Subject: AP1000 Response to Request for Additional Information (SRP 3)

RAI-SRP3.7.1-SEB1-10 R2

Response to Request for Additional Information on SRP Section 3

RAI Response Number: RAI-SRP3.7.1-SEB1-10

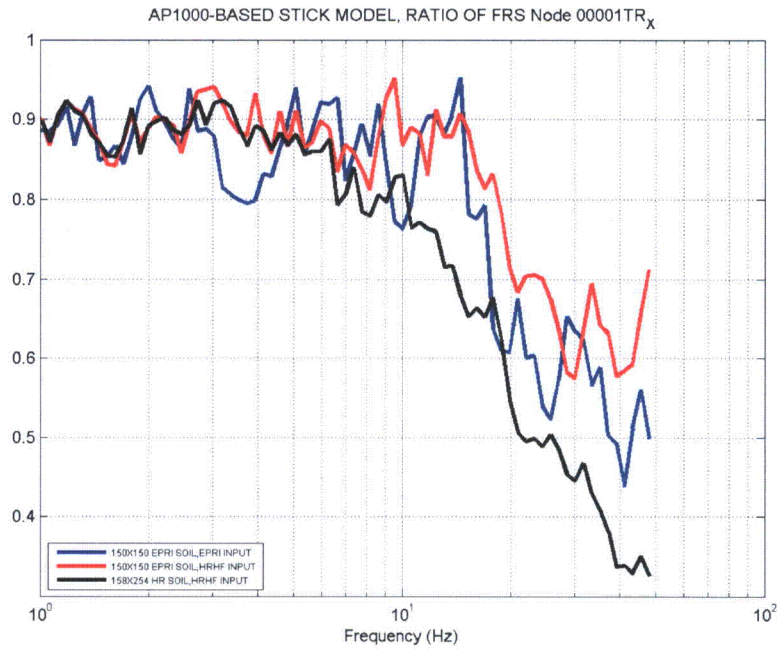
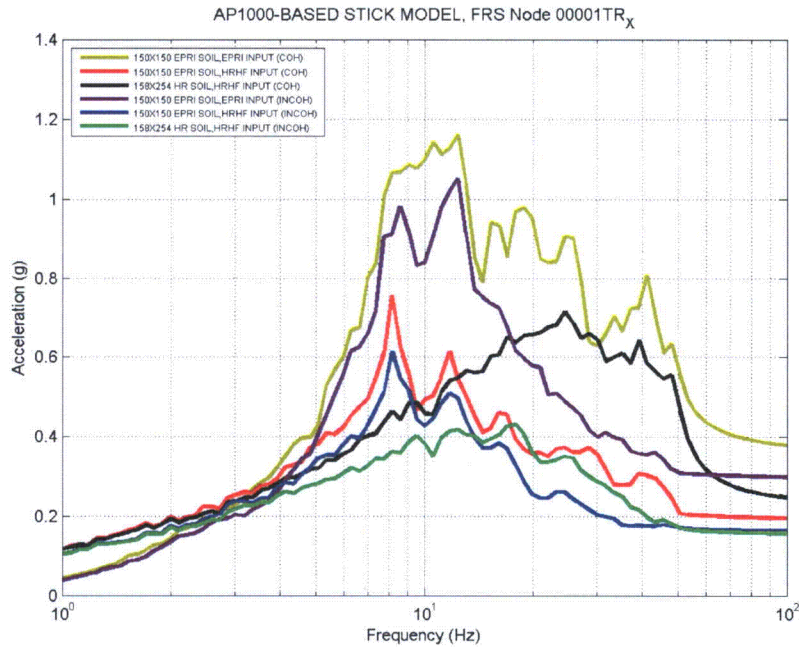
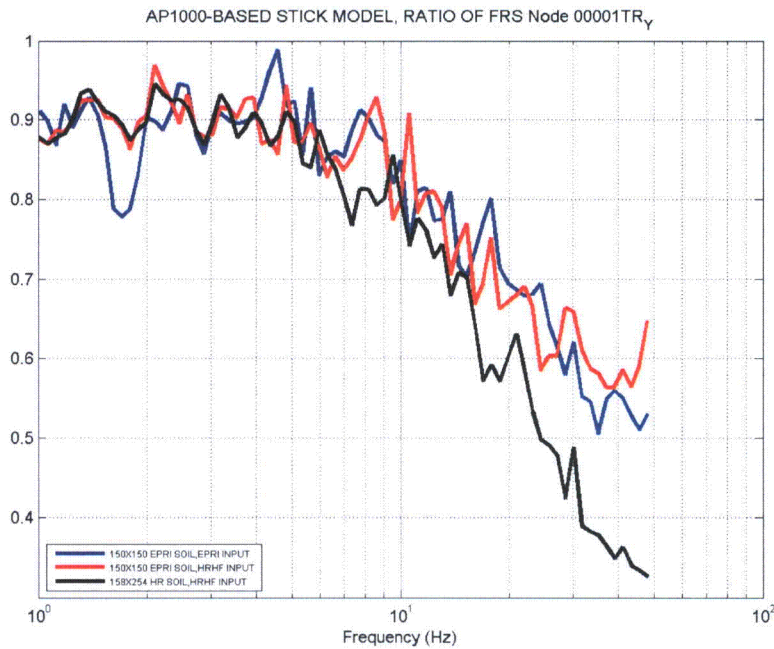
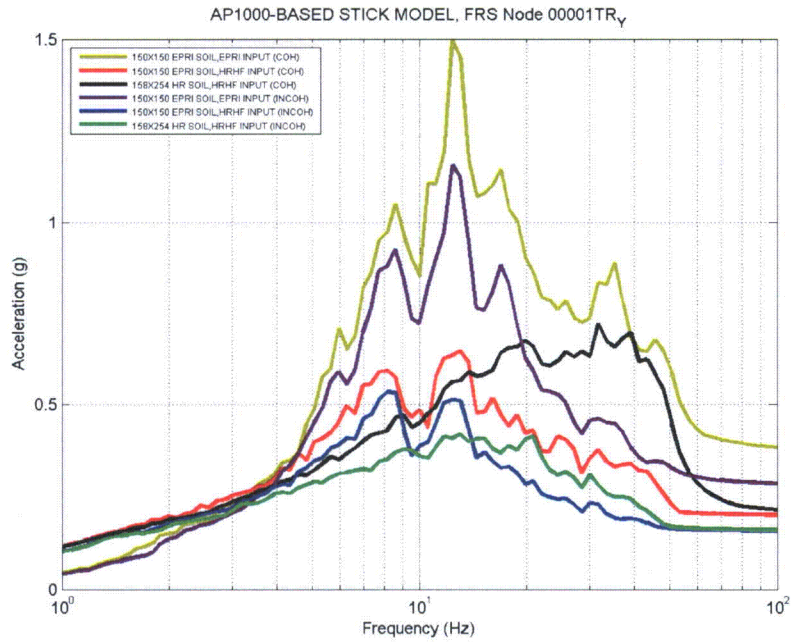
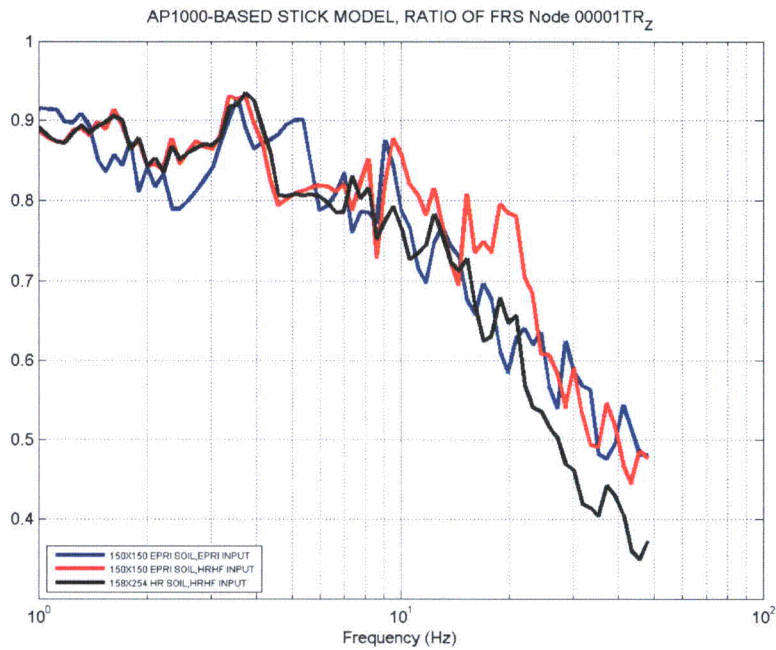
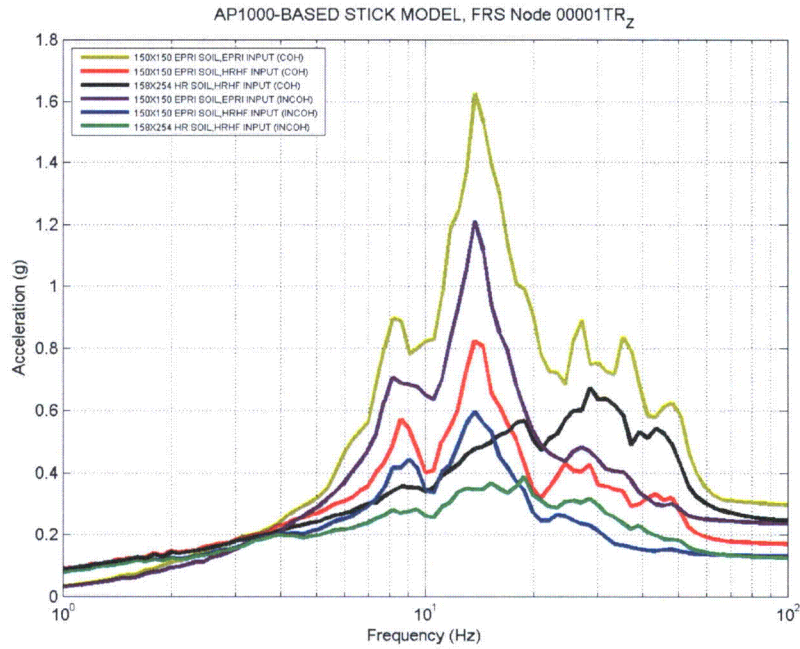
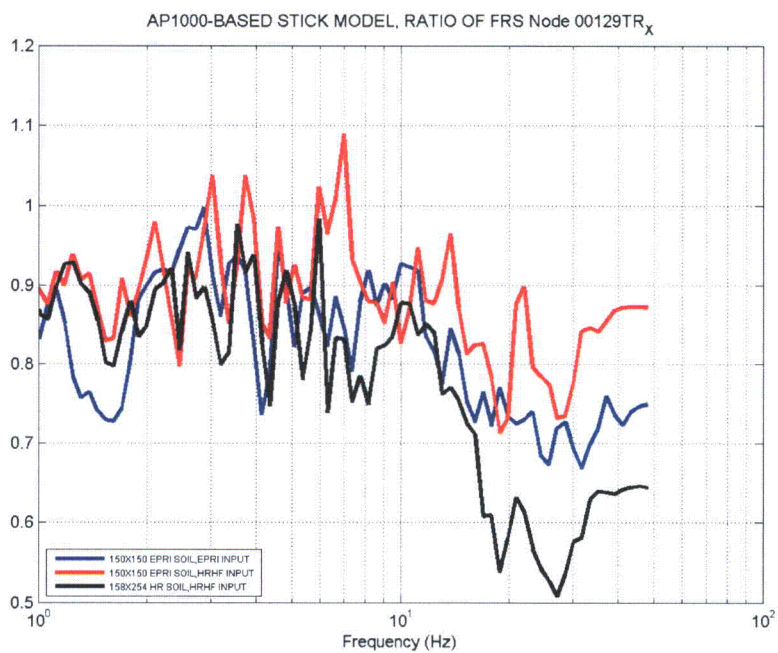
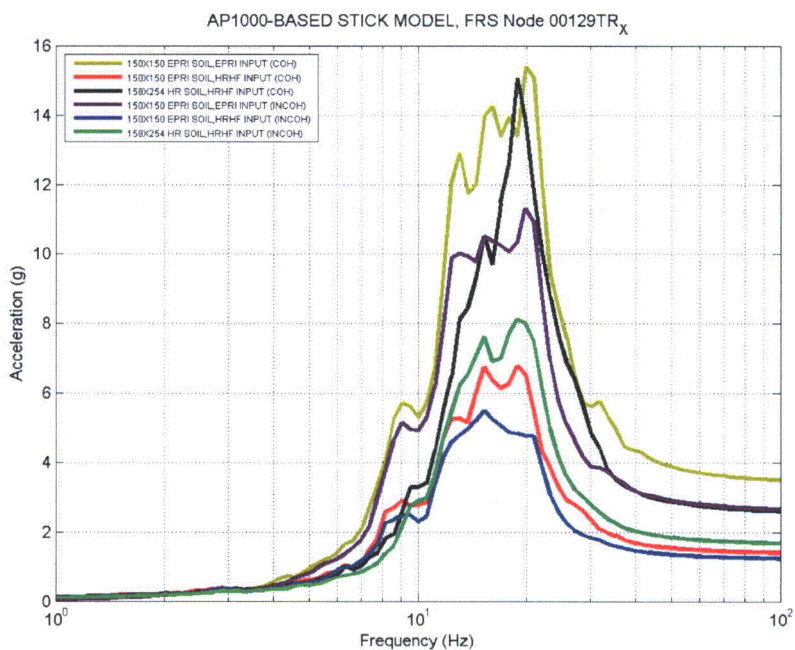
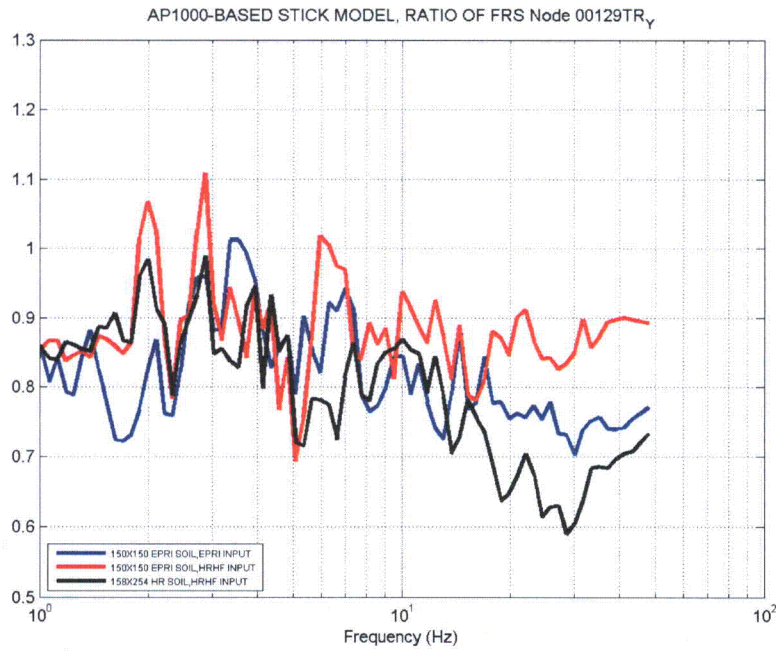
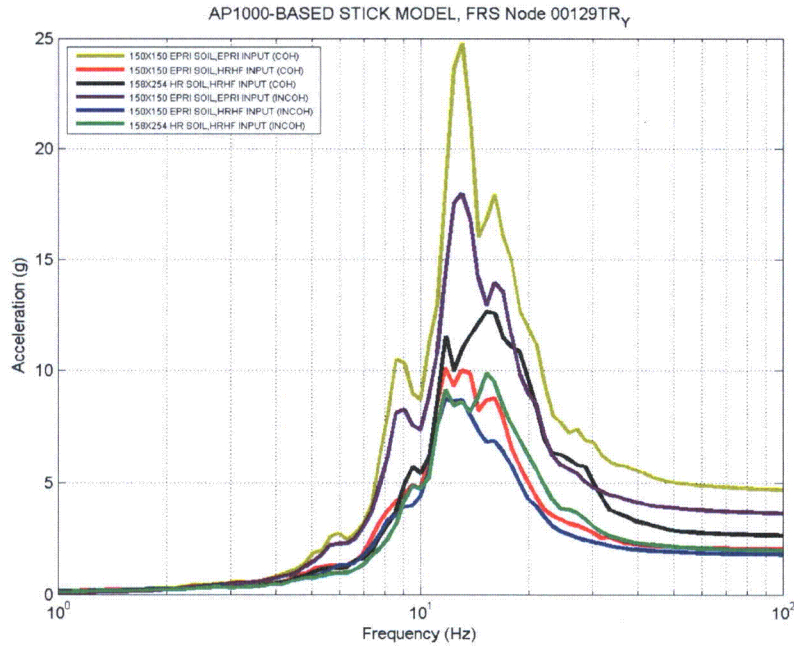
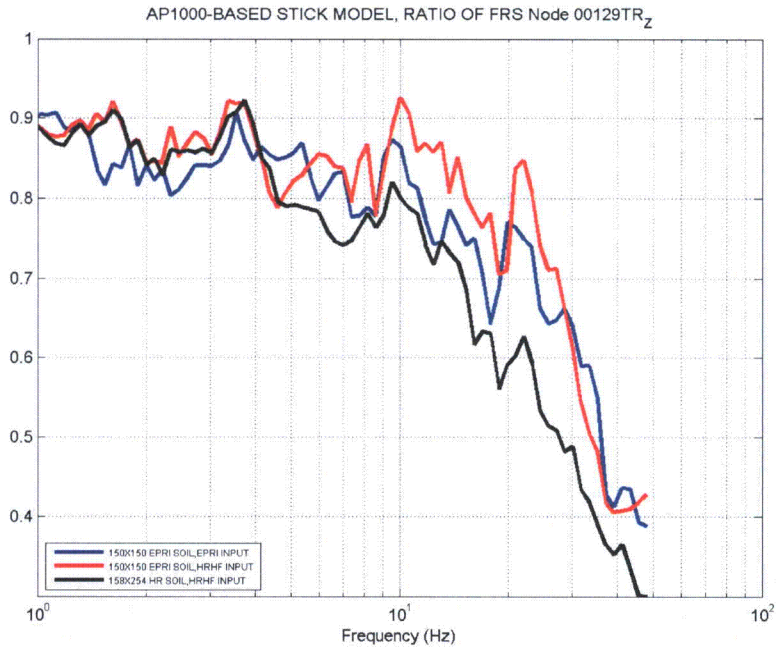
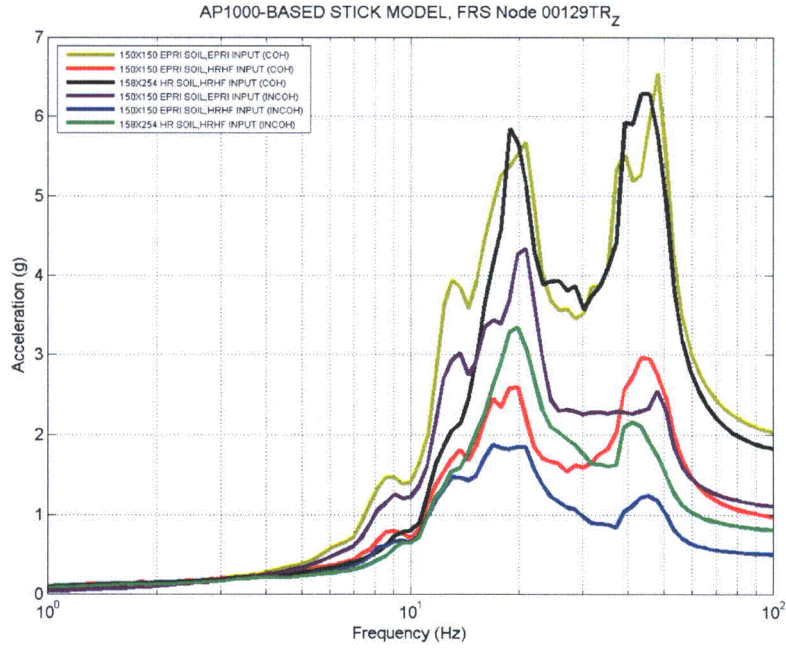
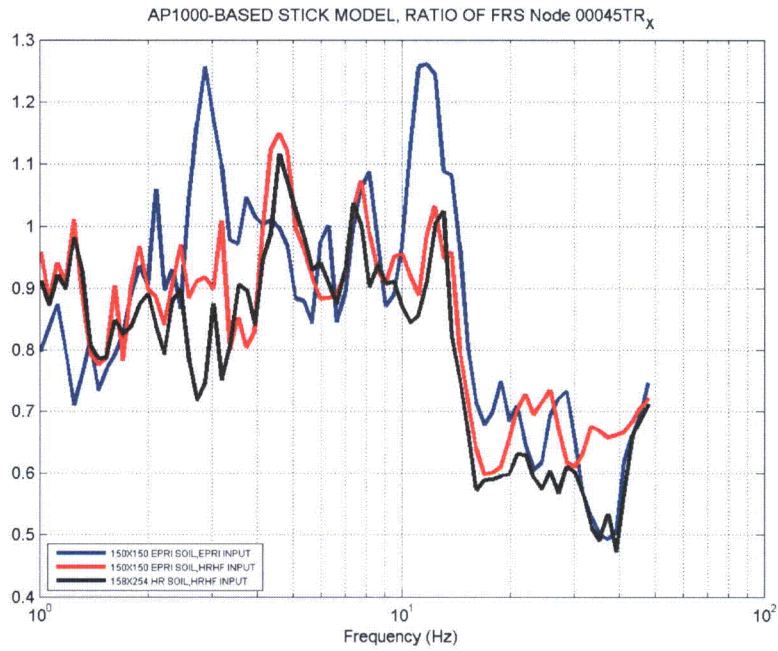
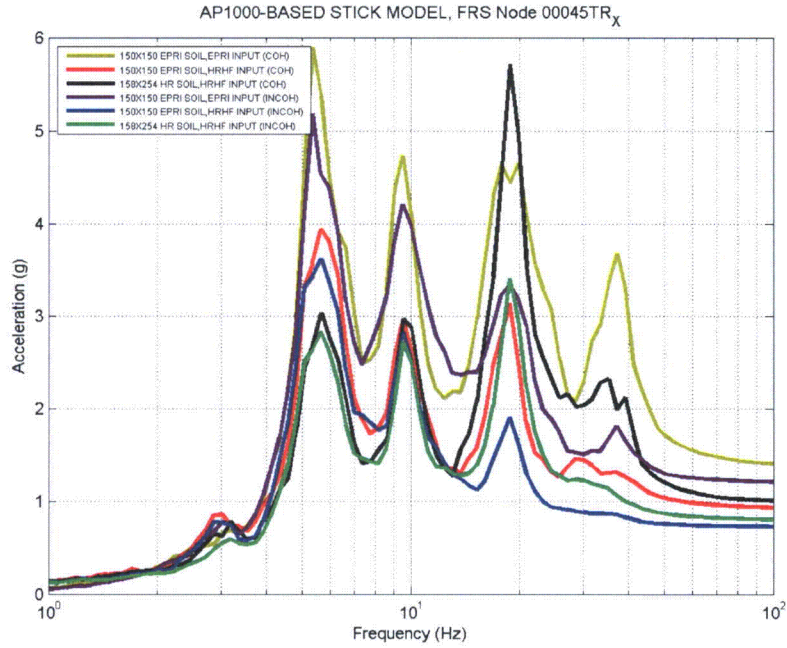
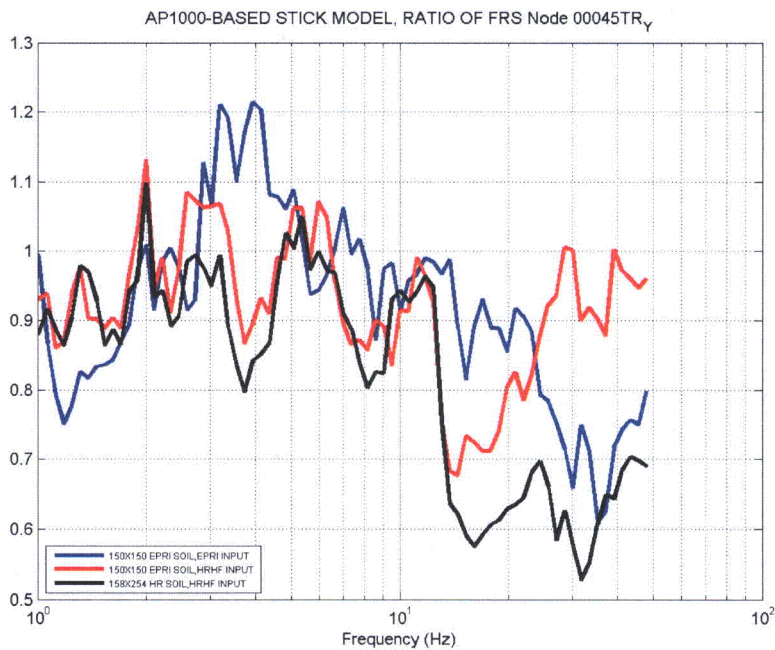
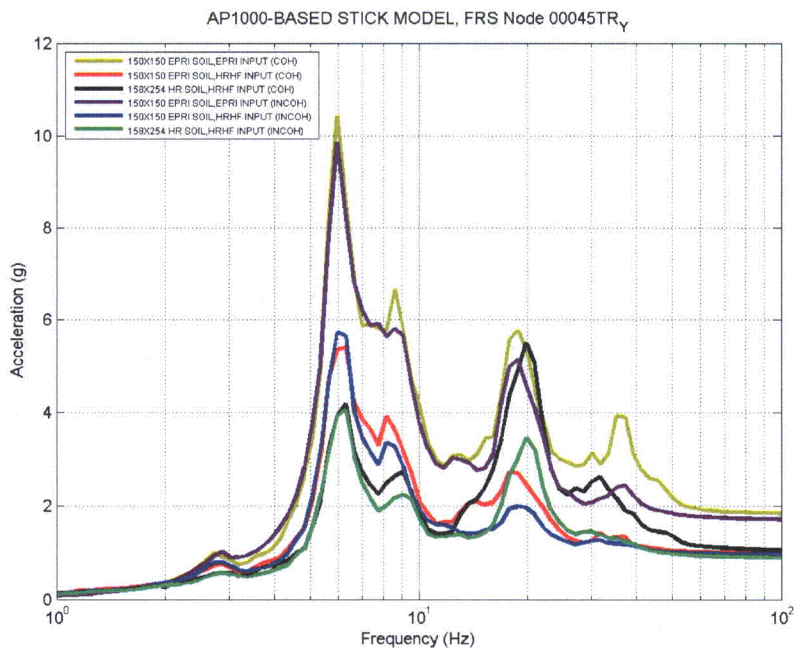
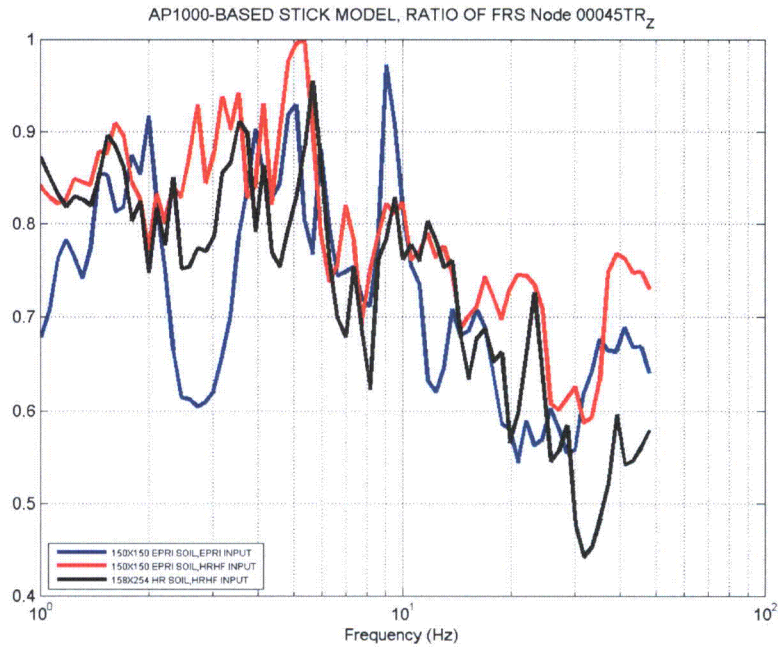
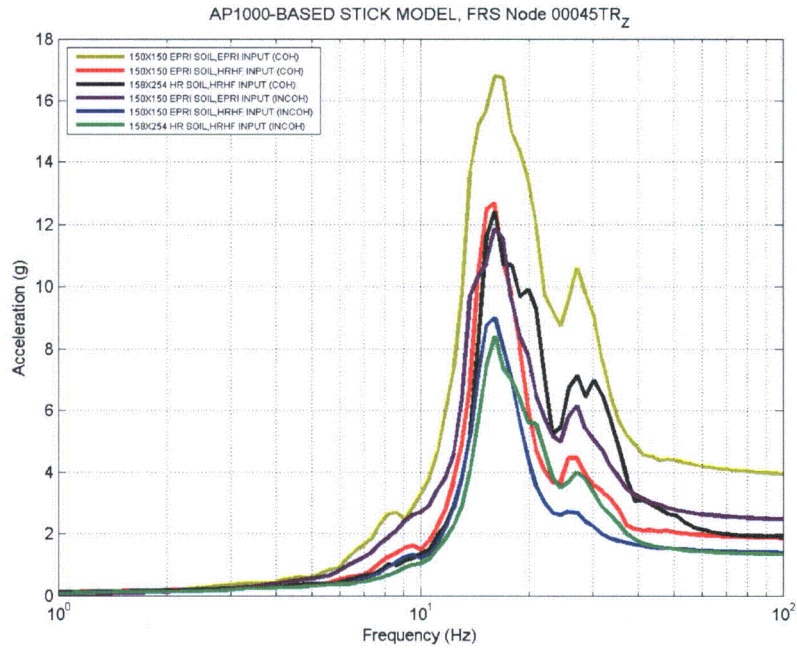
Perform additional calculations using EPRI model and rectangular foundation and AP1000 on hard rock foundation.

The 5% damping floor response spectra of four nodes and the reduction factors (Coh/Incoh) are shown in Figures RAI-SRP3.7.1-SEB1-10-22 to RAI-SRP3.7.1-SEB1-10-33. The Nuclear Island foundation results at elevation 60.5' (Node 1) show that the larger foundation will have larger reduction in response due to incoherency effects. The results for Top of Containment Internal Structure Mass Center at elevation 169' (Node 129), show reductions of the magnitude seen in the NI20 results. The top of the steel containment vessel and the top of the shield building also show similar results.
